Product Change Notification / SYST-25GSAN503

ERRATA - PIC16(L)F15356/75/76/85/86 Family Silicon Errata and Data Sheet Clarification Errata Document Revision

PIC16(L)F15356/75/76/85/86 Family Silicon Errata and Data Sheet Clarification

3.1 Figure 37-5: Clock Timing

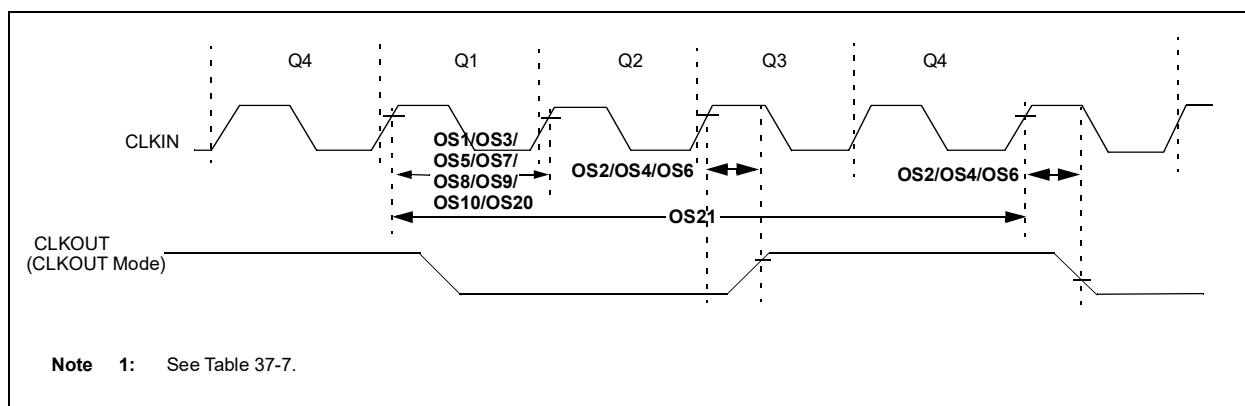
Figure 37-5 incorrectly shows the location of parameters OS1, OS2, OS3, OS4, OS5, OS6, OS7, OS8, OS9, OS10, OS20 and OS21. The correct location for the above-mentioned parameters is depicted in the following figure.

3.2 Figure 37-9: Brown-Out Reset Timing and Characteristics

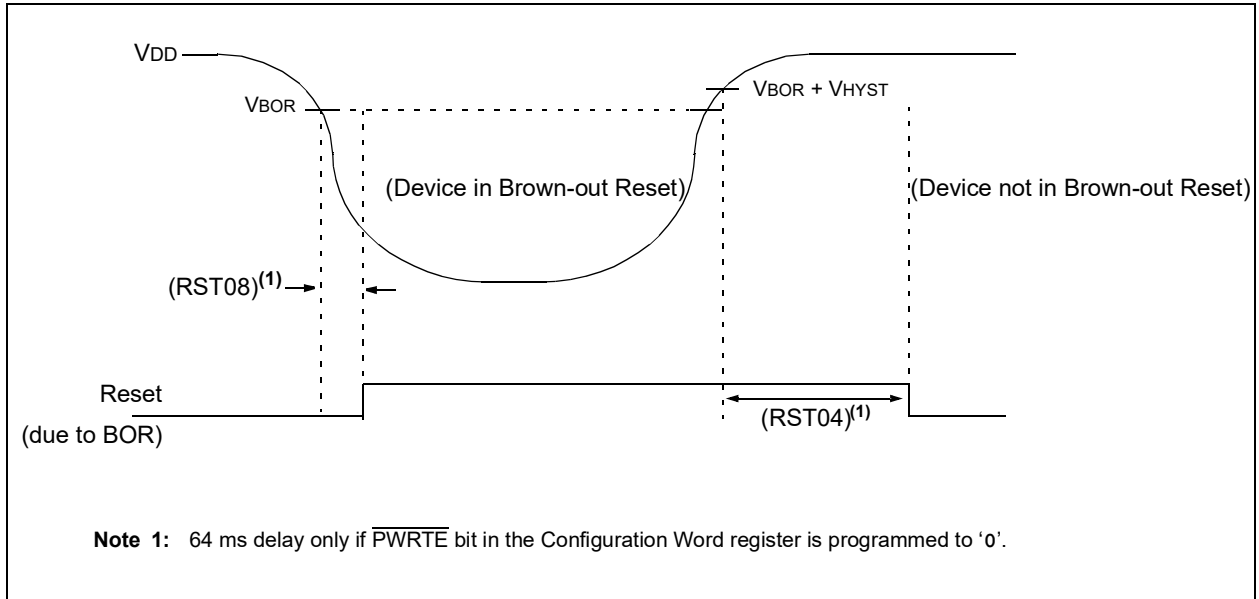
Note 1 in Figure 37-9 is incorrect. The correct note along with the figure is depicted below.
